Ref: A0123-B2-VWA-197

Re: ROSEHILL / CAMELLIA RECYCLED WATER SCHEME
Proposed Modification to Rosehill Recycled Water Scheme
Major Project Application No.: 07_0121 - As-Built Building Heights

Subject: Rosehill Recycled Water Scheme (MP 07_0121) – Mod 1

Re: ROSEHILL / CAMELLIA RECYCLED WATER SCHEME
Department of Planning Building and Tank Heights Condition 2.37

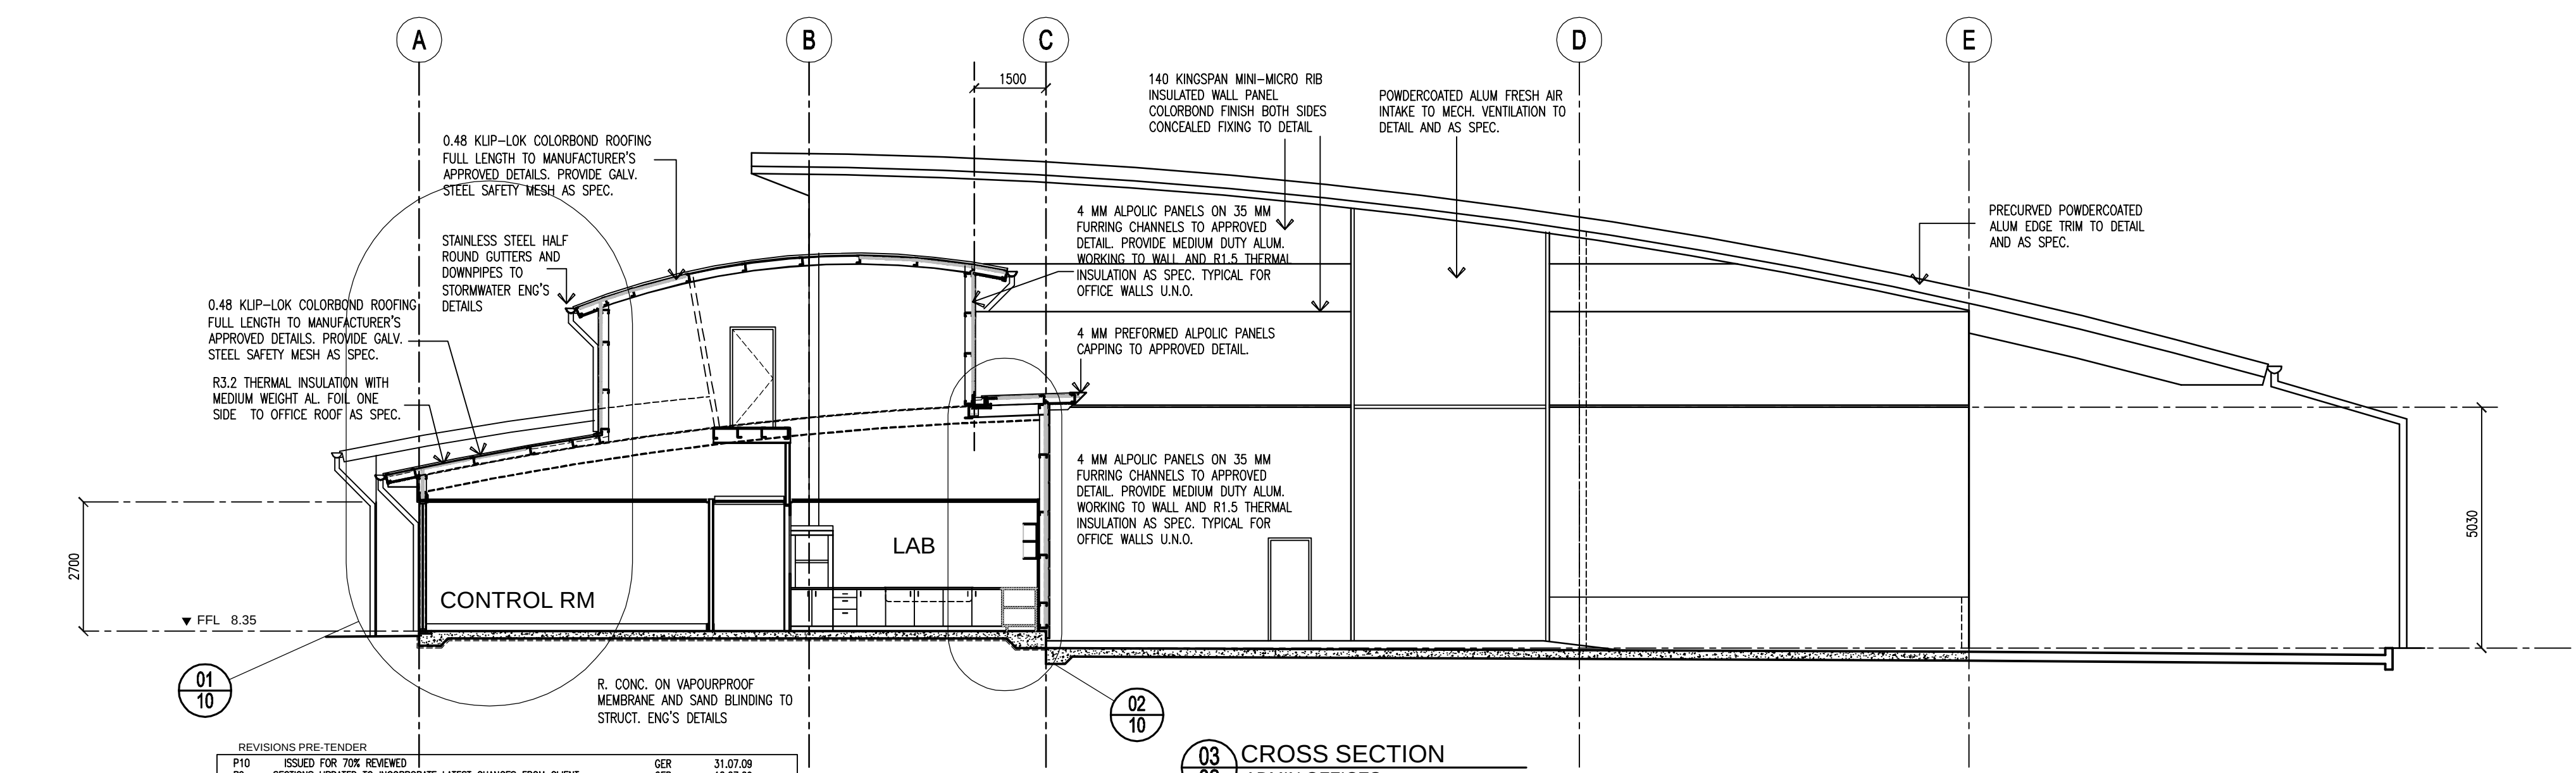
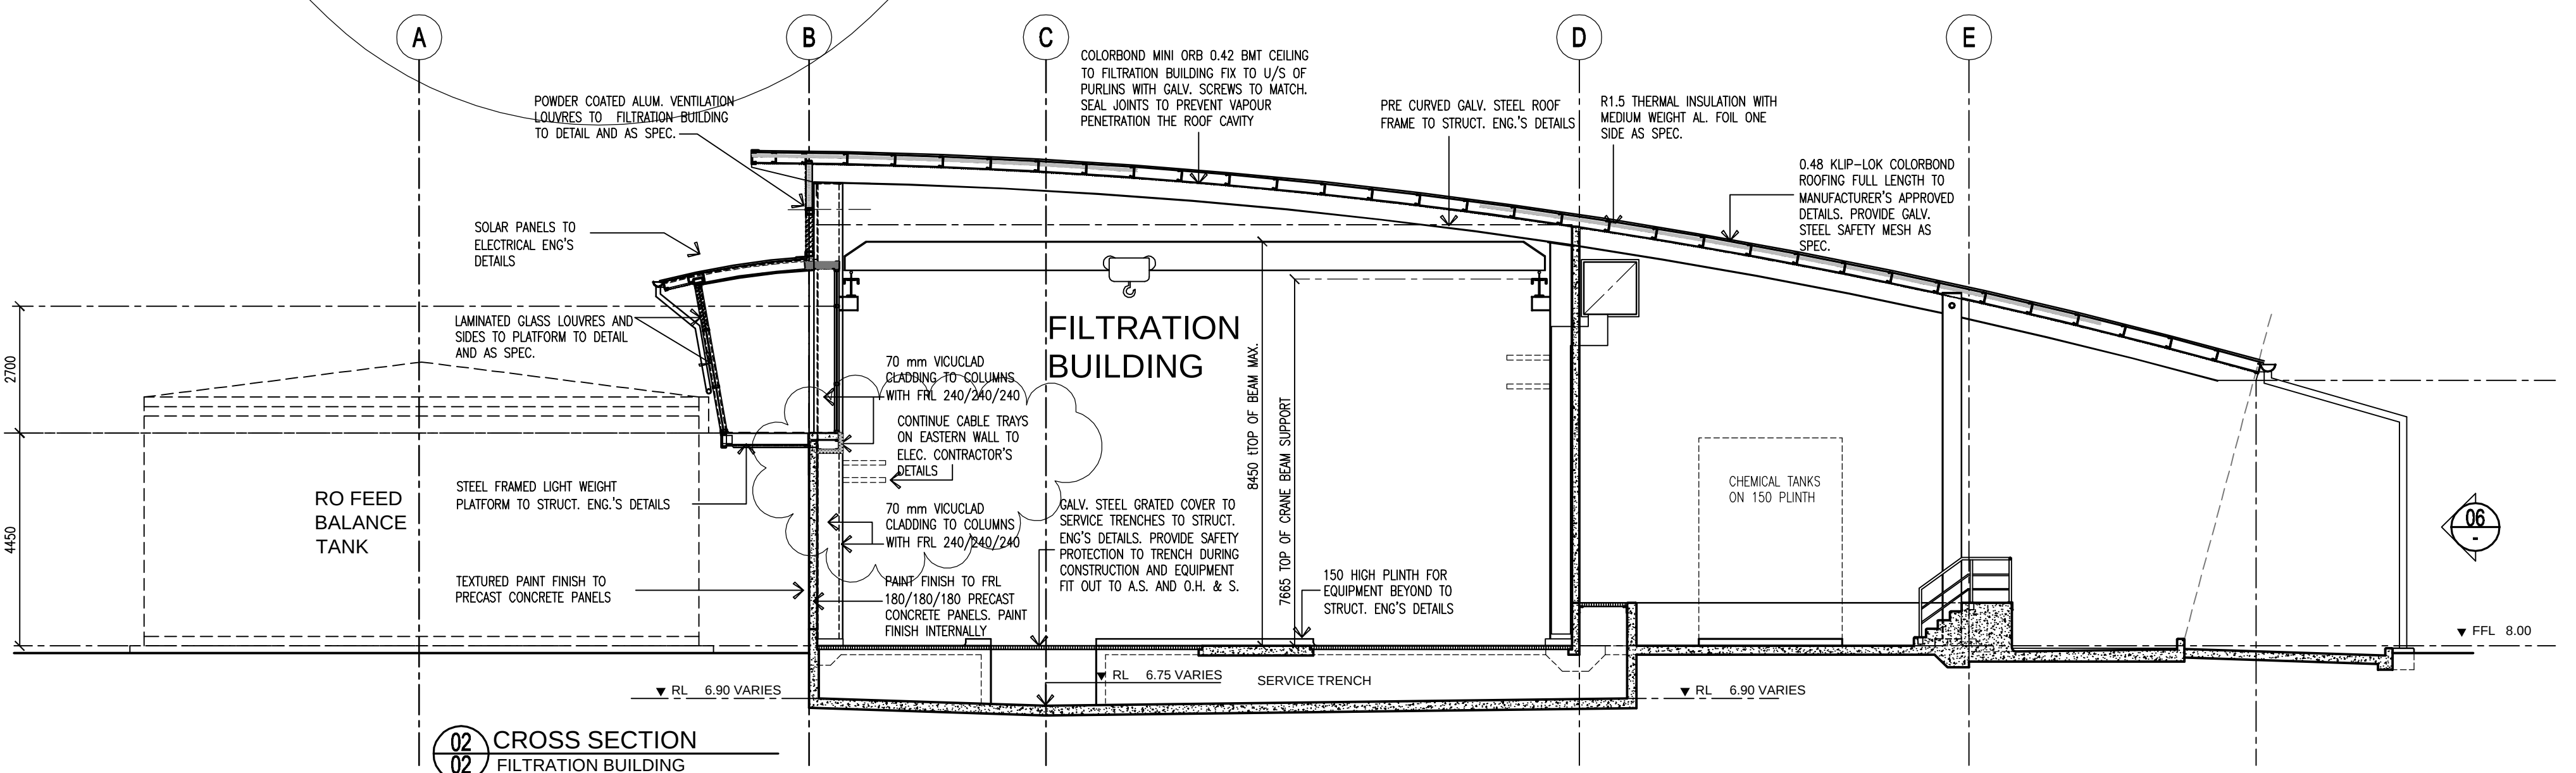
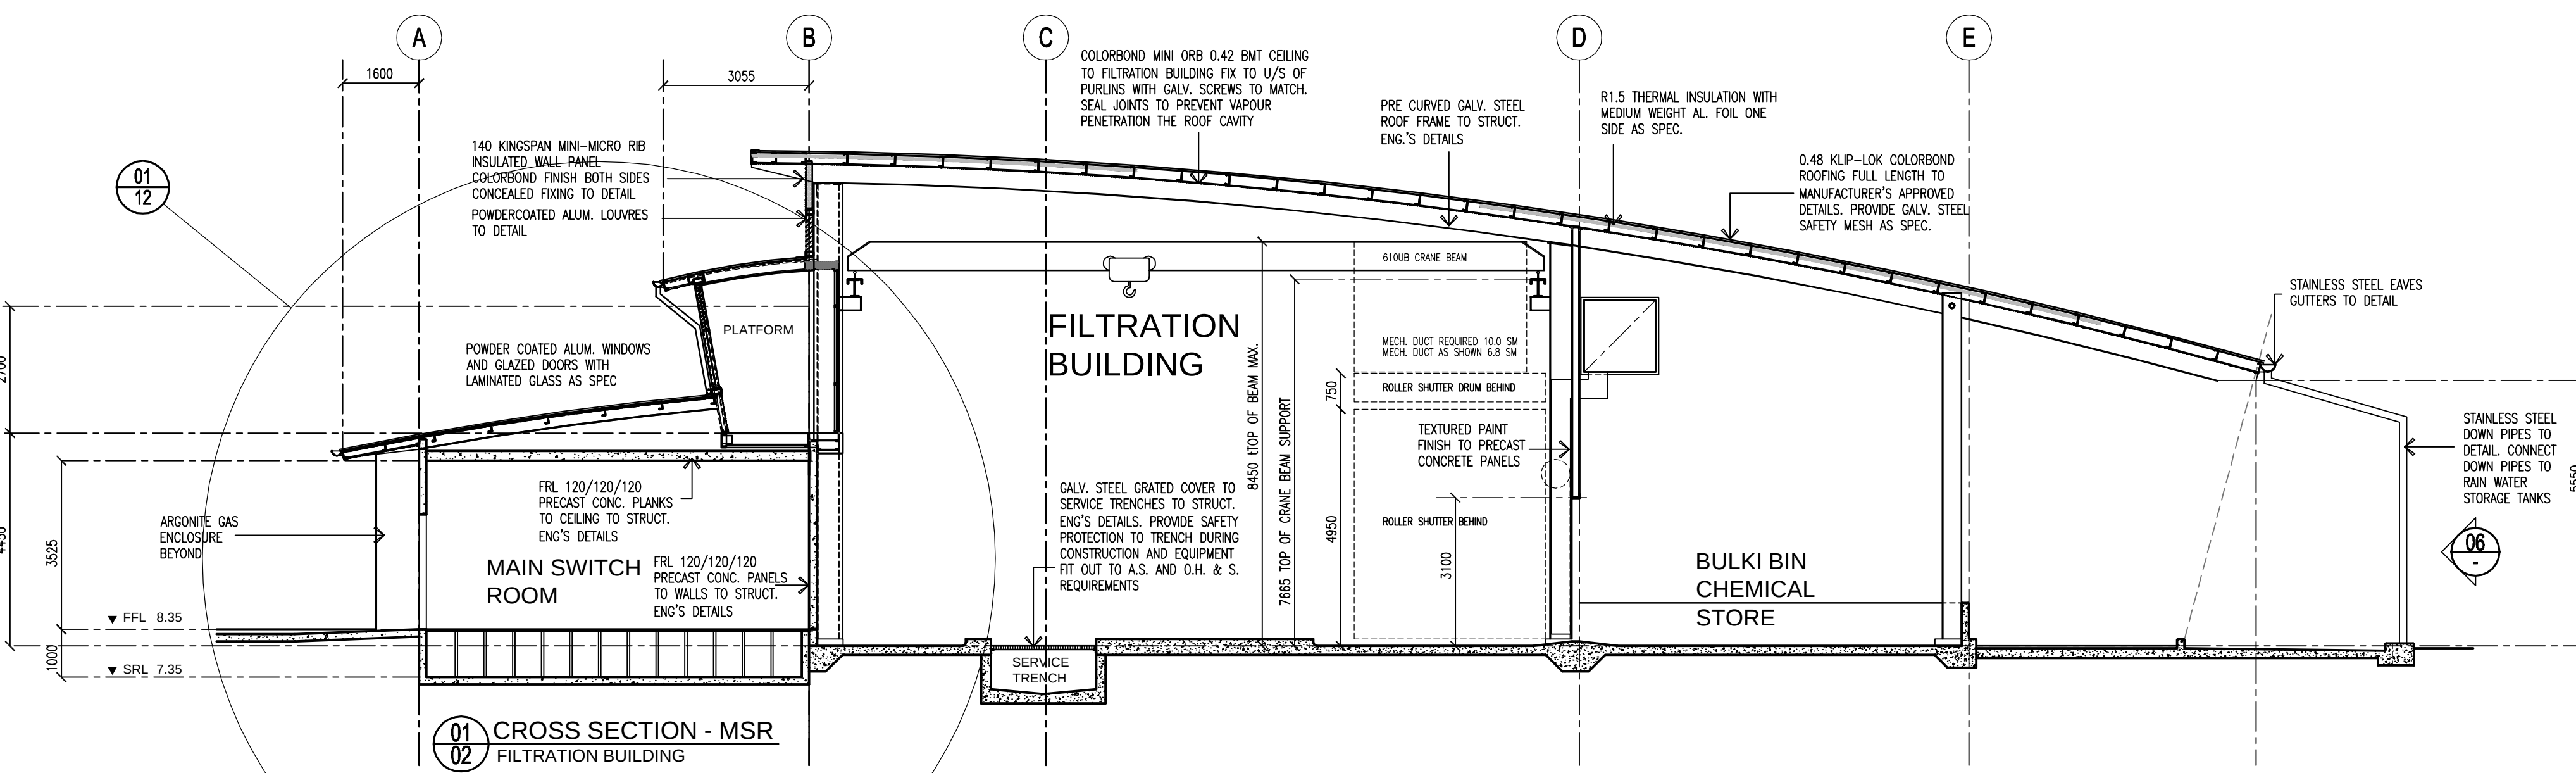
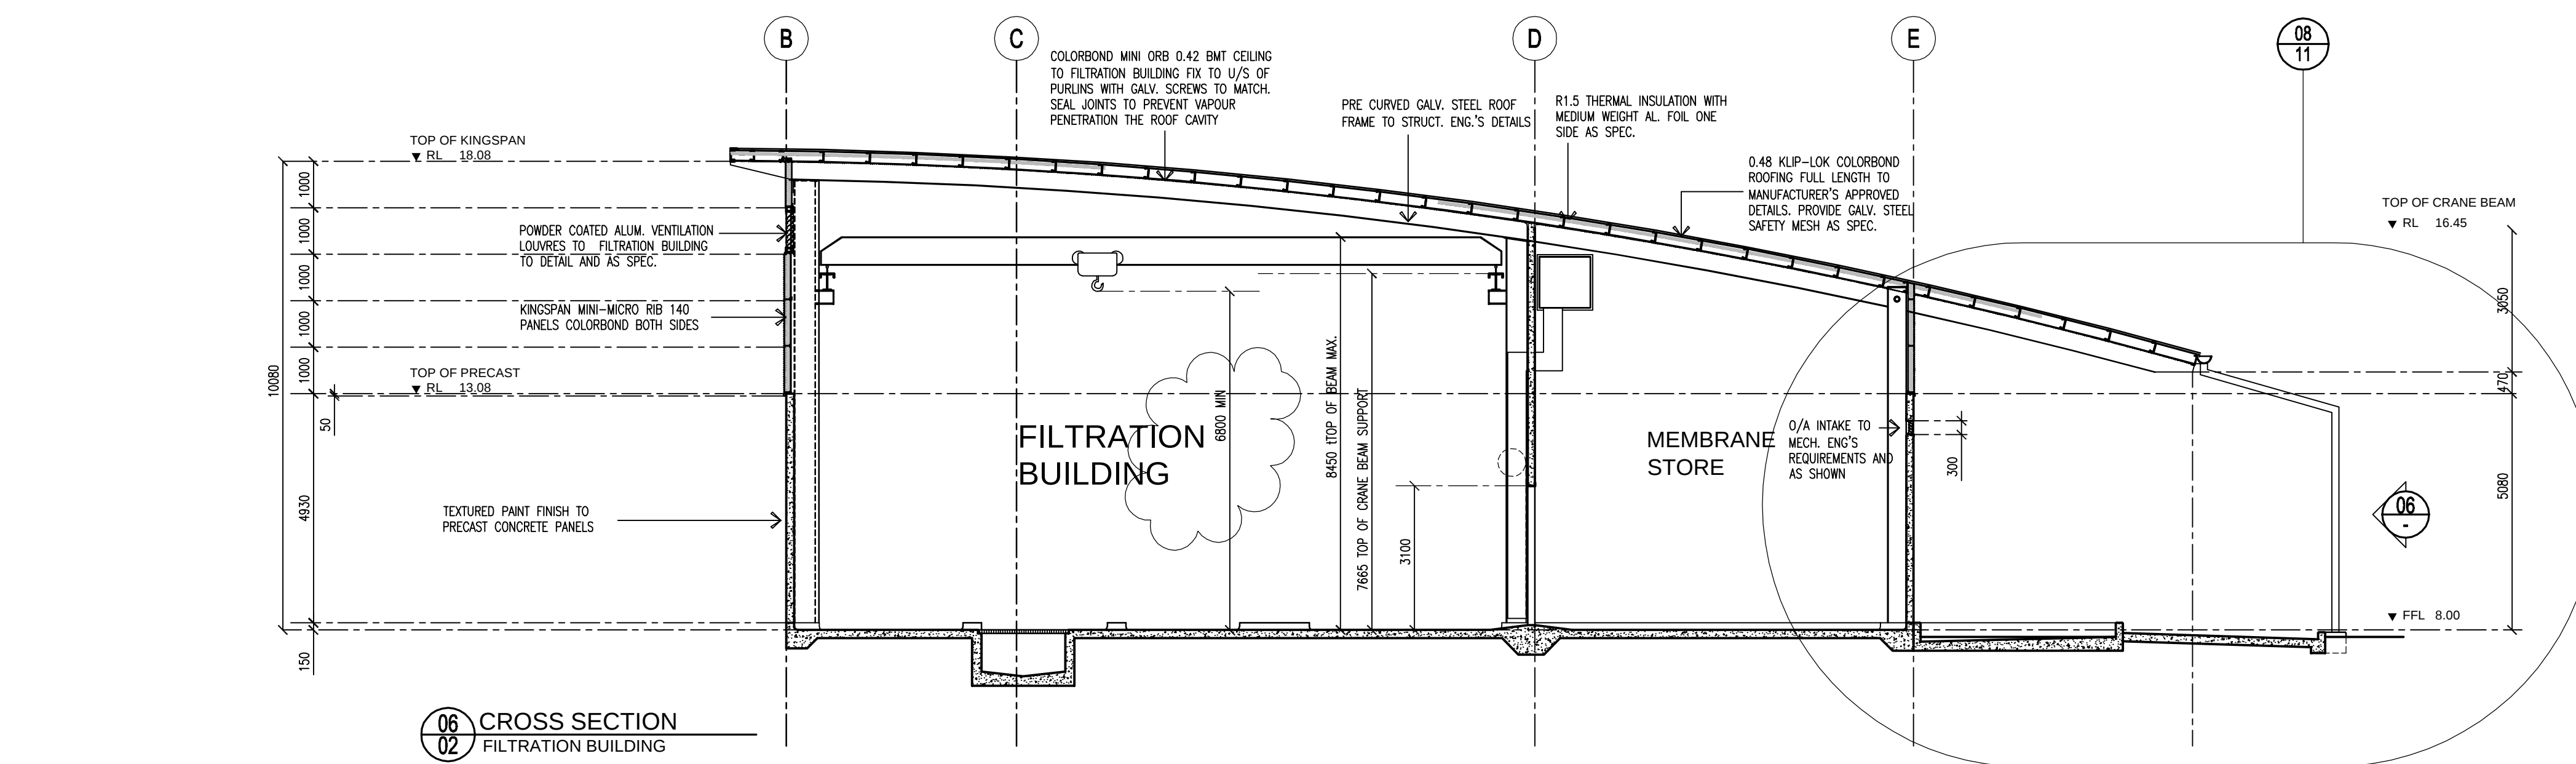
Out-of-Spec Item #1: Degasser Tower

Reference Plans:	1. Degasser Plan View A0123-H-5014-03 Rev E1 2. Surveyors Report 9091 033 Tank Levels
Allowable Height:	15.9m
As-built Height:	16.03m
Deviation:	0.13m
